Agenda Item # 2 SUB-002662-2023

Location: 2274 & 2278 Halls Mill Road

Subdivision Name: Elliot's Place Subdivision

• Subdivision approval to create one (1) legal lot of record from two (2) metes-and-bounds parcels.

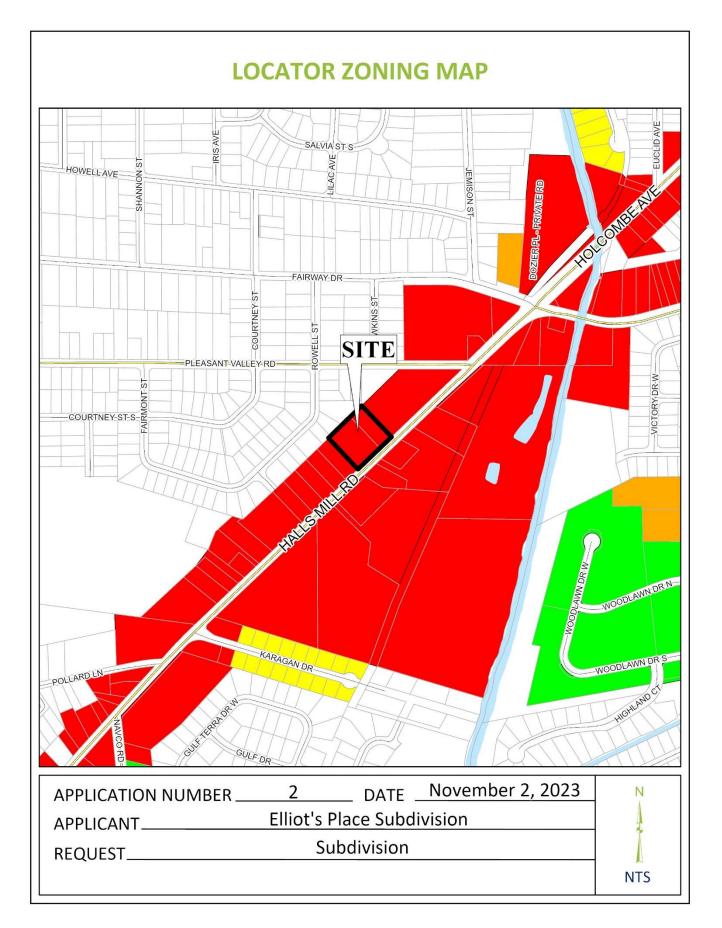
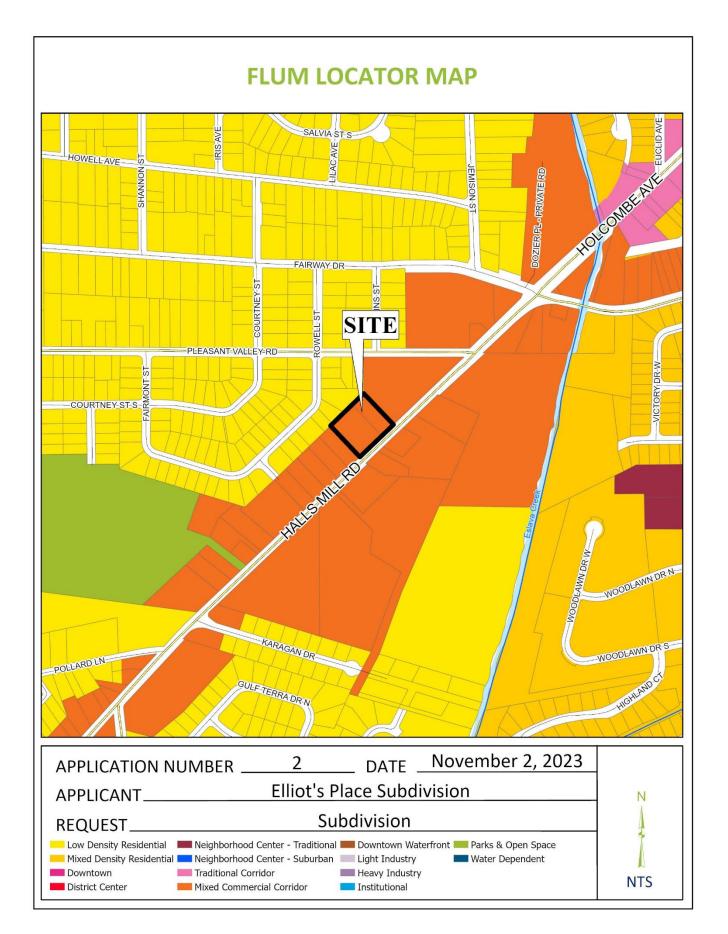
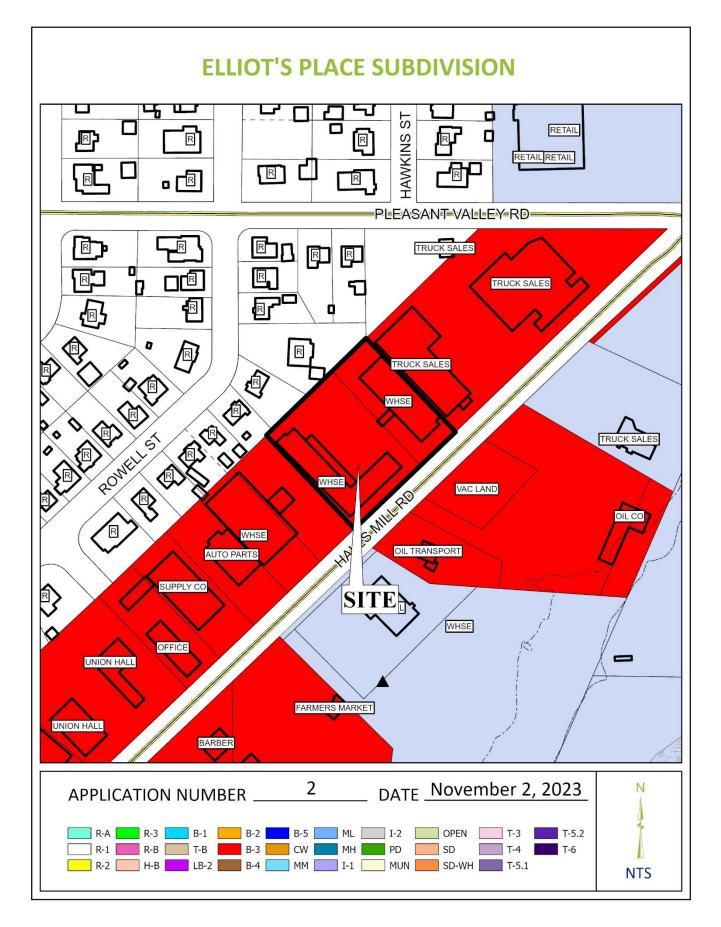
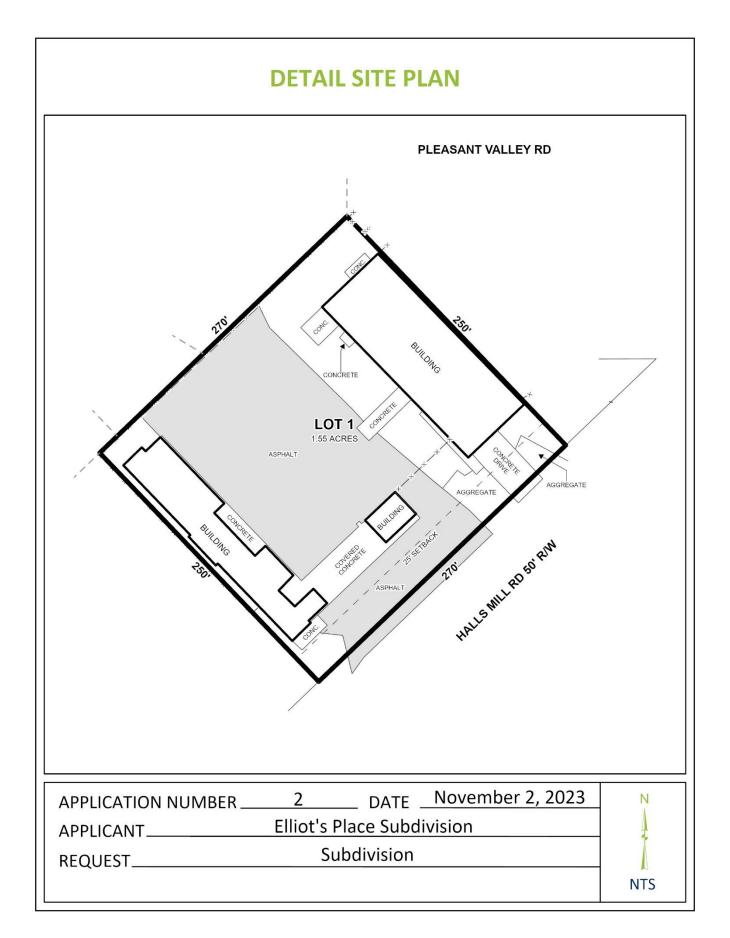
The proposed lot has frontage along Halls Mill Road, a Minor Arterial street requiring a 70-foot right-of-way at this location. The preliminary plat depicts a 50-foot right-of-way; as such, if approved, the Final Plat should be revised to illustrate dedication sufficient to provide at least 35 feet from the centerline of Halls Mill Road.

The lot, as proposed, exceeds the minimum size requirement for lots served by public water and sanitary sewer in the B-3 Suburban district. Its size is appropriately labeled in square feet and acres on the preliminary plat. If approved, this information should be retained on the Final Plat, adjusted for dedication; or, provision of a table on the Final Plat with the same information will suffice.

The 25-foot minimum front yard setback is illustrated along Halls Mill Road, but it should be noted that the additional right-of-way dedication will cause an awning on one of the existing buildings to encroach within this setback, creating a non-conforming condition. Future improvements to the building may require a smaller awning to comply with the 25-foot setback requirement; or, the applicant can request a Front Yard Setback Variance from the Board of Zoning Adjustment to allow a reduced front yard setback at that time. Nevertheless, if approved, the 25-foot front yard setback line along Halls Mill Road should be retained on the Final Plat, adjusted for dedication.

- 1. Revision of the plat to illustrate dedication sufficient to provide 35 feet from the centerline of Halls Mill Road;
- 2. Retention of the lot size labels in square feet and acres, adjusted for dedication, or provision of a table on the Final Plat with the same information;
- 3. Retention of the 25-foot front yard setback line along Halls Mill Road, adjusted for dedication;
- 4. Compliance with all Engineering comments noted in this staff report;
- 5. Placement of a note on the Final Plat stating the Traffic Engineering comments noted in this staff report;
- 6. Compliance with all Urban Forestry comments noted in this staff report; and
- 7. Compliance with all Fire Department comments noted in this staff report.
